ADVANCED GEOTECHNICAL SOLUTIONS, INC.

March 28, 2022
PW 1912-01
Report No. 1912-01-B-6
City of San Diego Project No. 698277

Subject: **Geotechnical Addendum and Response to LDR-Geology Cycle 2 Review Comments, Multifamily Residential Development, 555 Hollister Street, San Diego, California**

SPT Name: B-5

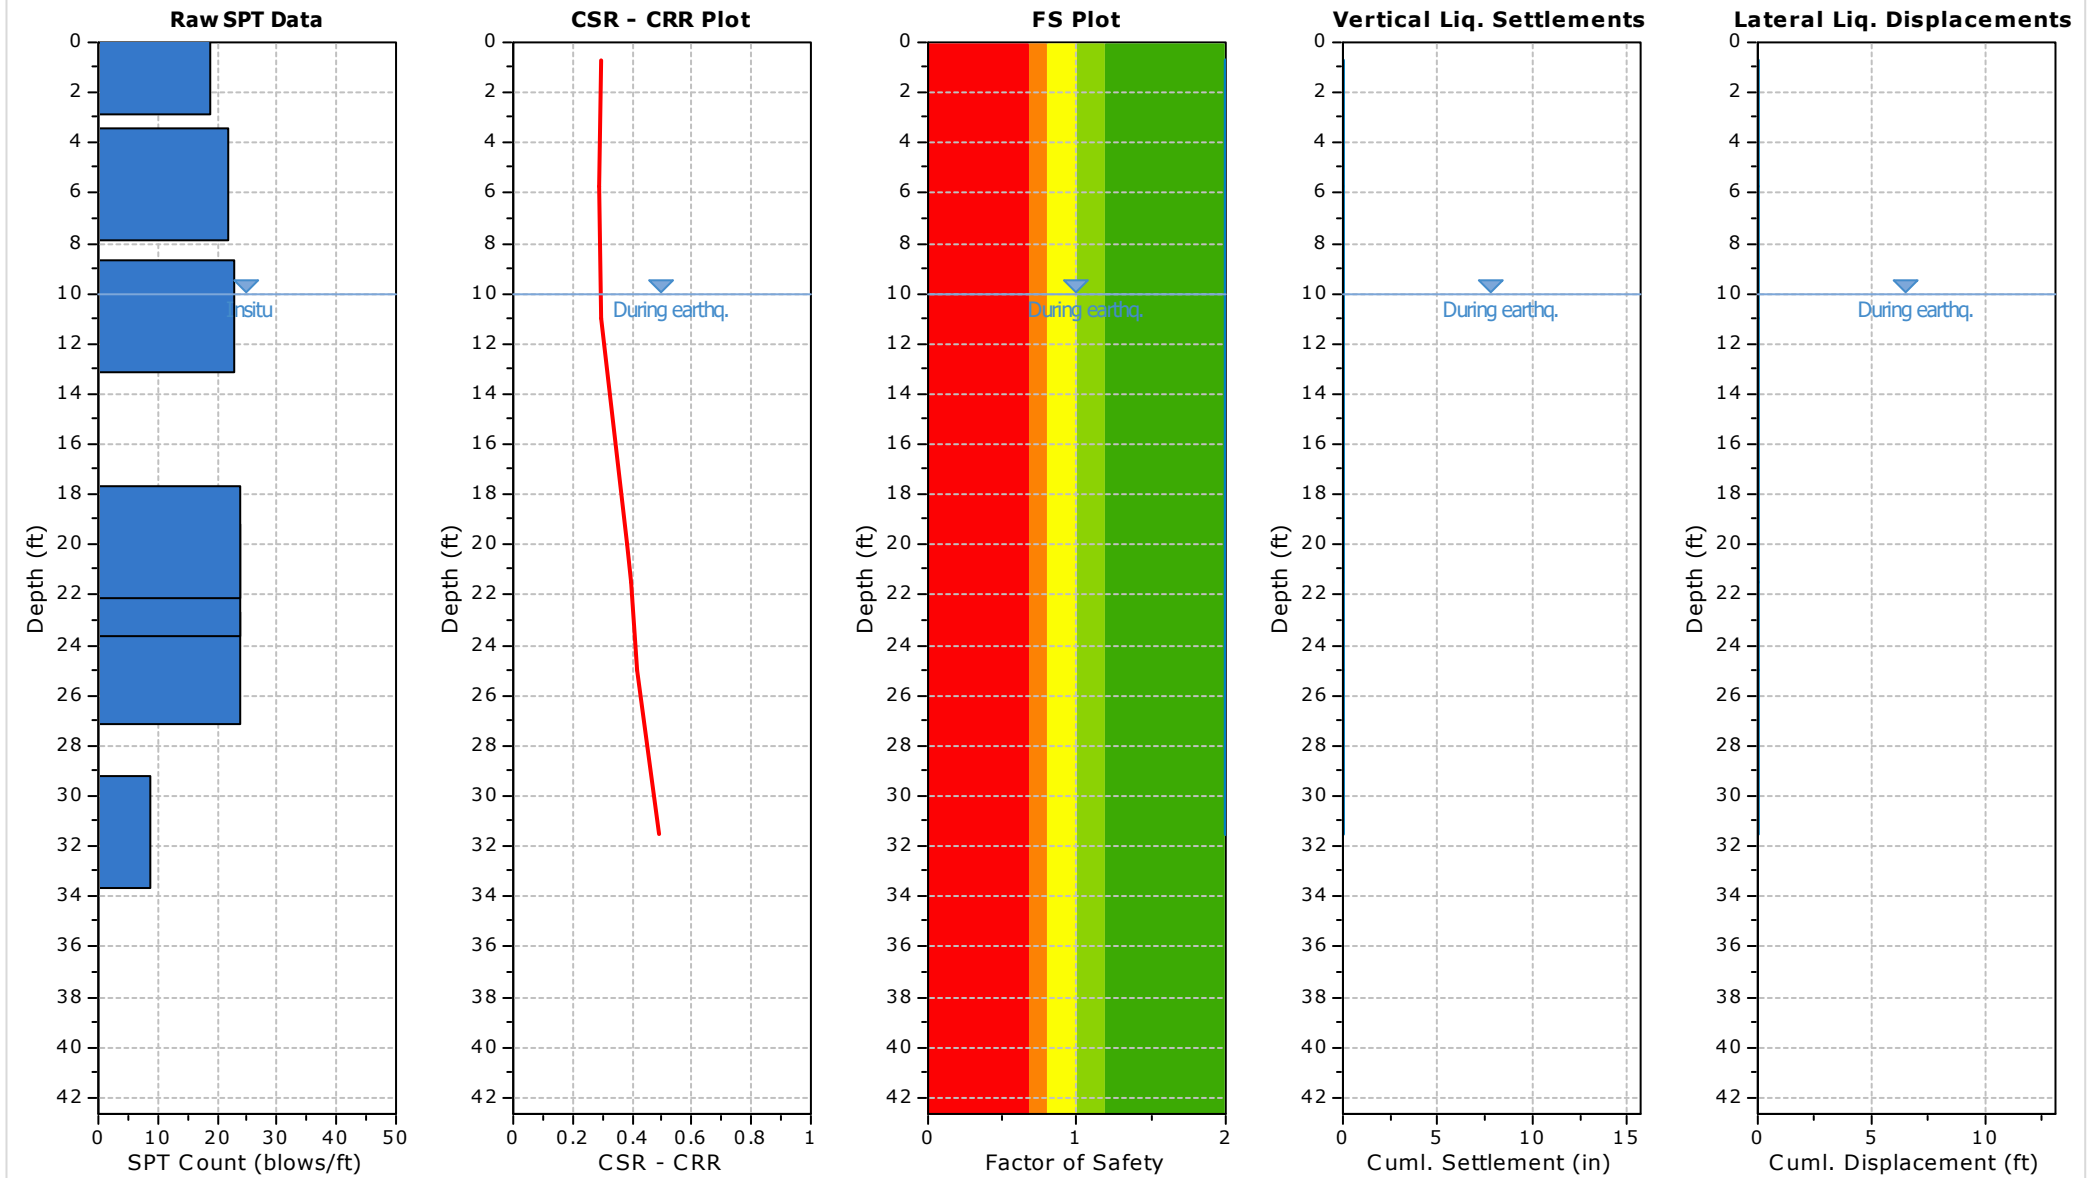
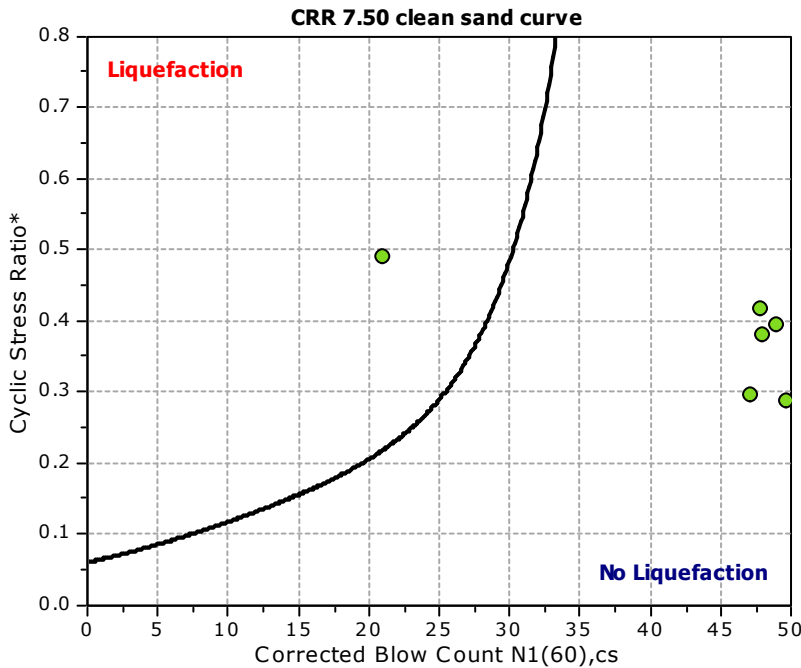
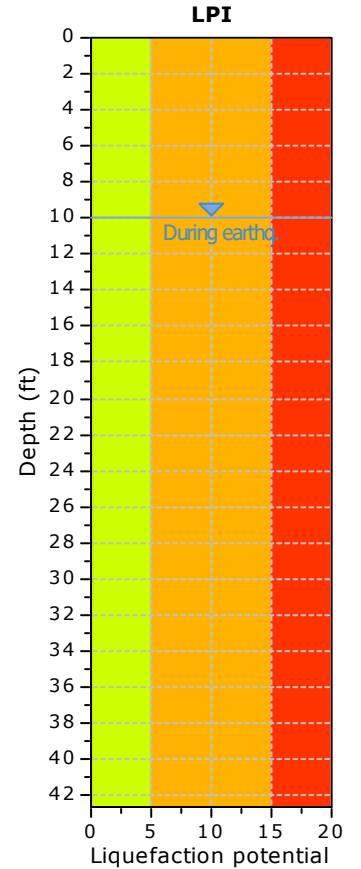
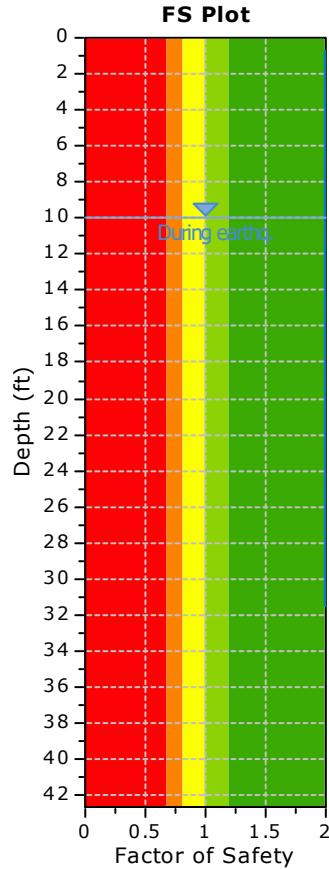
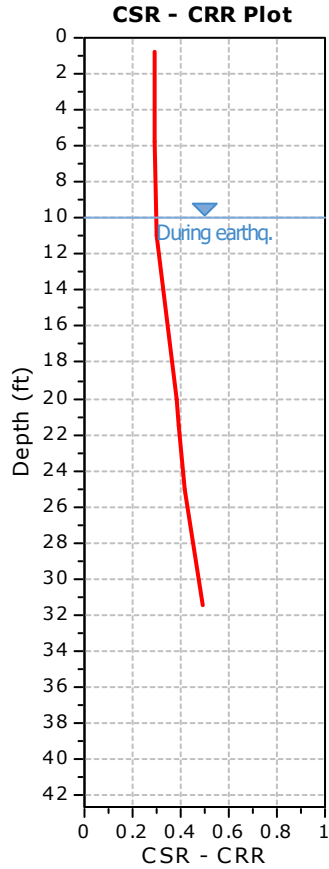
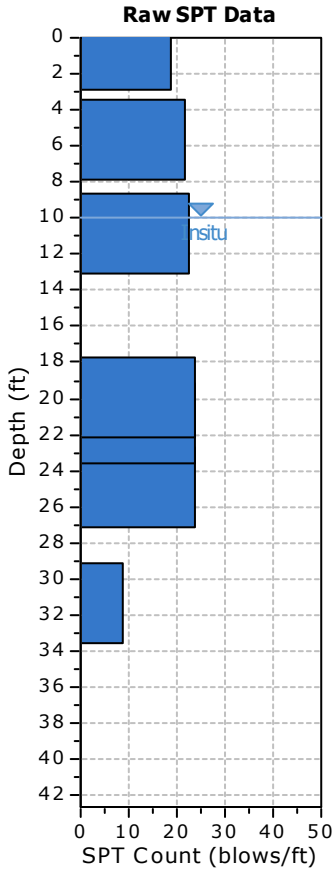
Item 5 -City of San Diego- *An area of the project site is located in geologic hazard category (GHC) 31 as shown on the City's Seismic Safety Study Geologic Hazard Maps. GHC 31 is characterized by a high potential for liquefaction. The geotechnical consultant must specifically address liquefaction potential of the entire site and potential consequences of soil liquefaction on the proposed development/ project.*

Liquefaction and dry sand settlement analyses were performed using the computer program LiqSVs v.2.2 (Geoligismiki, 2019) and subsurface data from borings B-5 and B-7. The analyses considered an earthquake moment magnitude of 6.9, peak ground acceleration PGA_M of 0.62g, and groundwater level at El. 12.5 feet msl. Our analyses indicate that no liquefaction settlement will occur in boring B-5 and B-7. Dry sand settlement of approximately 0.5 inches during a seismic event was estimated at about 5 foot depth within boring B-5 as shown in Appendix B.

As indicated in Section 6.1.2 - Removals of the referenced geotechnical report by AGS (2021a), the alluvial materials at the toe of the descending slope and the undocumented fill on the slope should be removed and recompacted. After the recommended removal and recompaction, dry sand settlement of the upper layer within boring B-5 will be mitigated to a negligible level. It is our opinion that the remedial grading measures will mitigate any liquefaction potential onsite and the potential consequences of soil liquefaction on the proposed development/project.

SPT Name: B-7

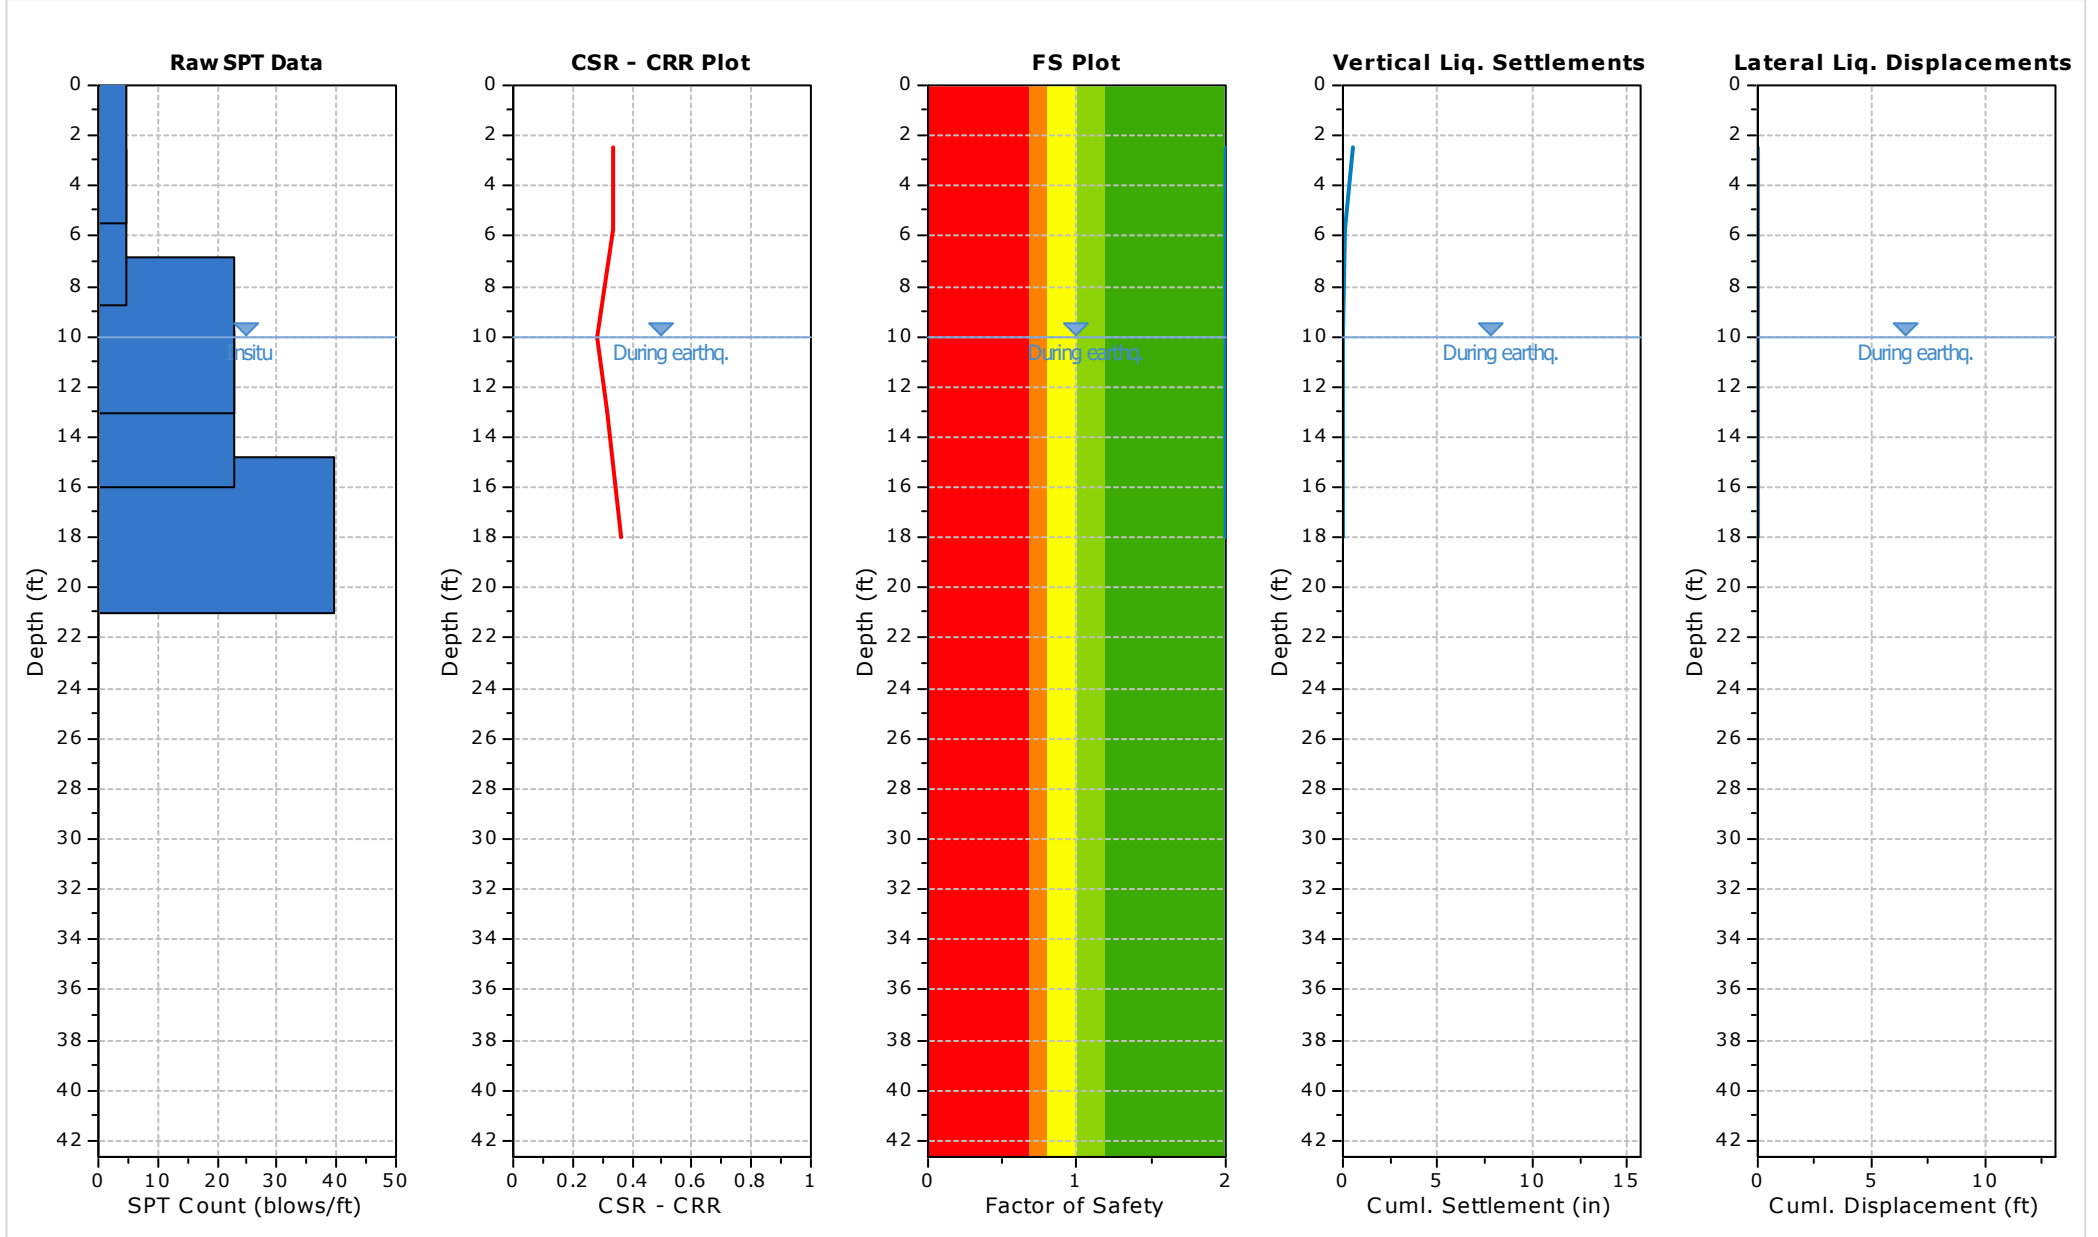
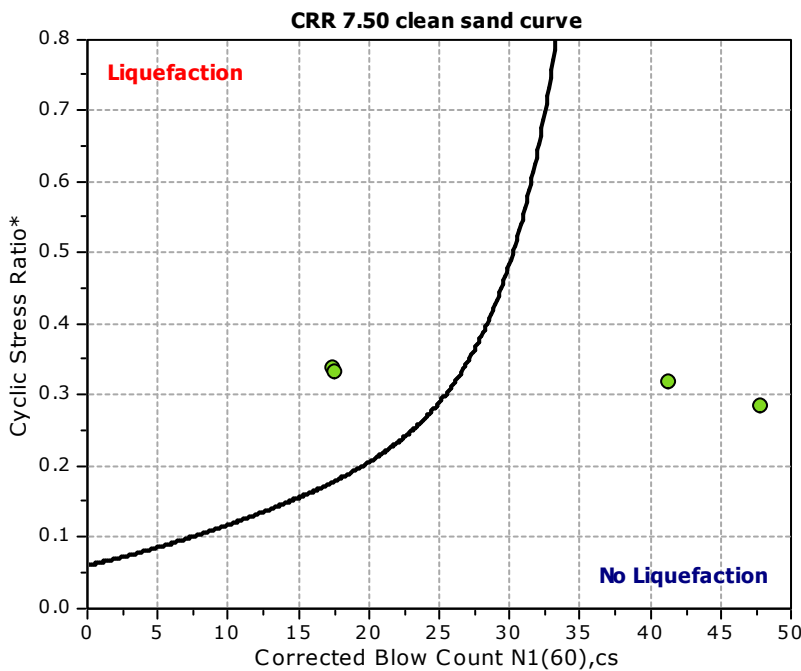
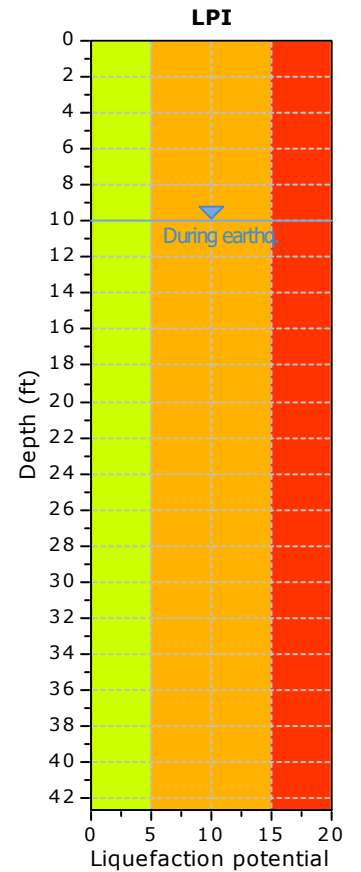
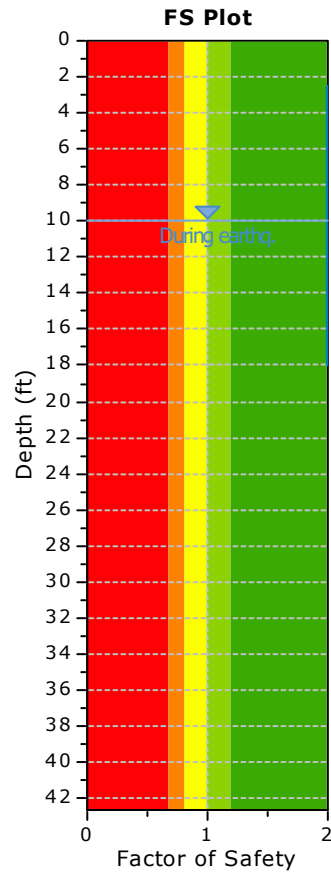
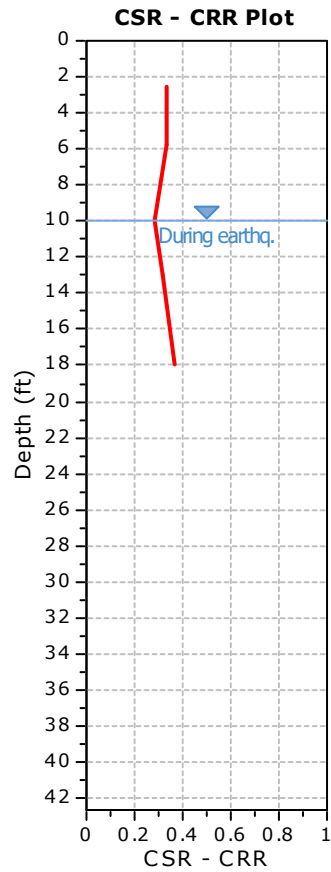
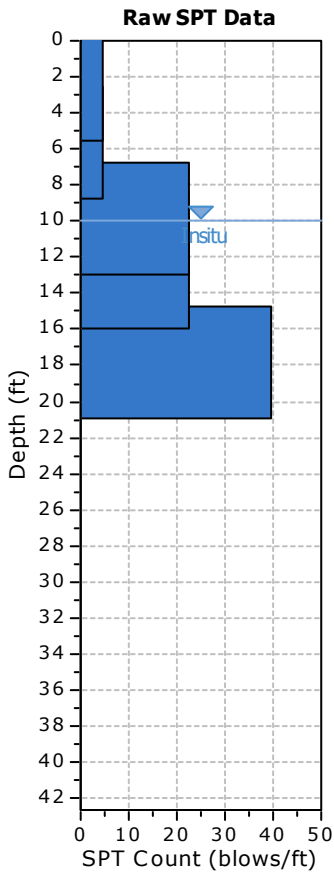
Item 6 -City of San Diego- *Address lateral spread or flow slide potential of the site. If impacts are indicated, provide recommended mitigation measures.*

AGS Response – The liquefaction analyses presented in Appendix B indicate that the potential displacement due to lateral spread for borings B-5 and B-7 is zero. Since the recommended removal and recompaction measures will mitigate liquefaction onsite, it is anticipated that any potential lateral spread will also be mitigated.
